**ADDENDUM
(FINAL ENVIRONMENTAL IMPACT STATEMENT)**

**Decommissioning of Eight
Surplus Production Reactors
at the Hanford Site,
Richland, Washington**

December 1992

U.S. DEPARTMENT OF ENERGY

Figure 3-27. Flooded area for the probable maximum flood (after ERDA, 1976).

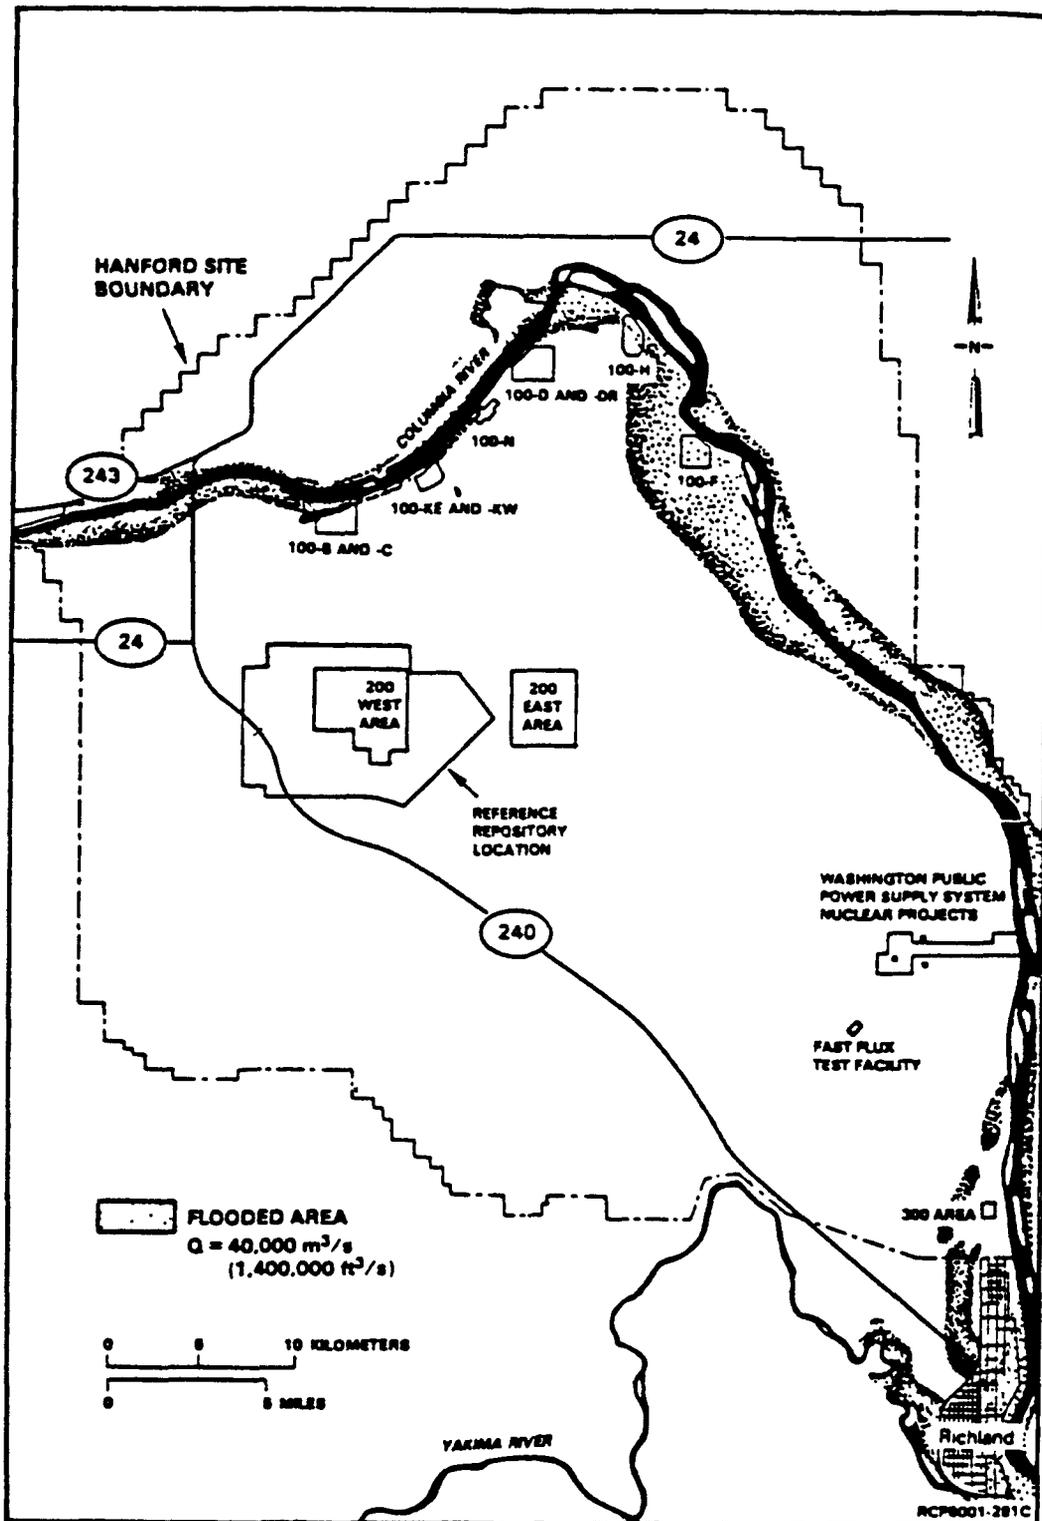
L042-C08. Columbia River flow alteration could be caused by factors in addition to climatic changes (page 3.57). The FEIS should describe erosion and accretion processes that could change the river channel and lead to immersion of the reactors.
